# UNITED STATES PATENT AND TRADEMARK OFFICE

APPLICATION NO.	FILING DATE	FIRST NAMED INVENTOR	ATTORNEY DOCKET NO.	CONFIRMATION NO.
10/572,228	02/08/2007	Andrew Davidson	2006982-0001	1255

<b>Office Action Summary</b>	<b>Application No.</b> 10/572,228	<b>Applicant(s)</b> DAVIDSON ET AL.	
	<b>Examiner</b> WILLIE BERRY	<b>Art Unit</b> 3652

## **DETAILED ACTION**

Fig. 1

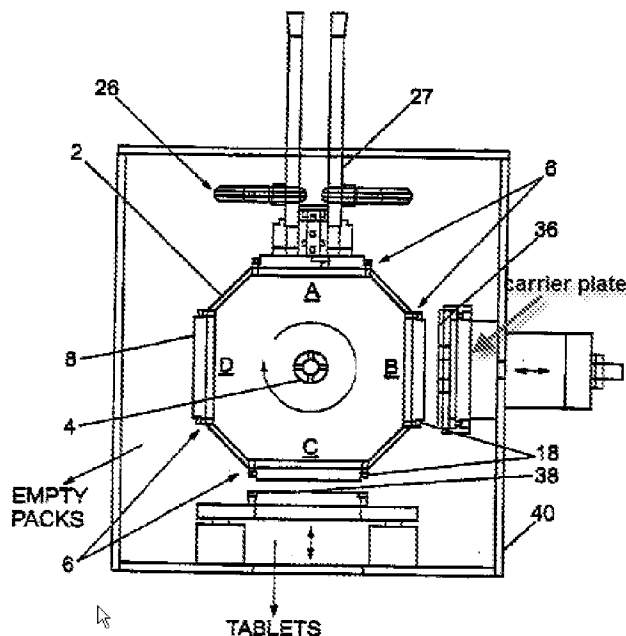
Regarding claim 11, Parker et al. discloses a carrier plate (shown in the figure 1 below) and cutting pieces (36 and col. 4, lines 20-23).

Regarding claim 14, Parker et al. discloses a lidding material cutting means movable between a rest position and a cutting position (col. 4, lines 15-23 and see figure 1).
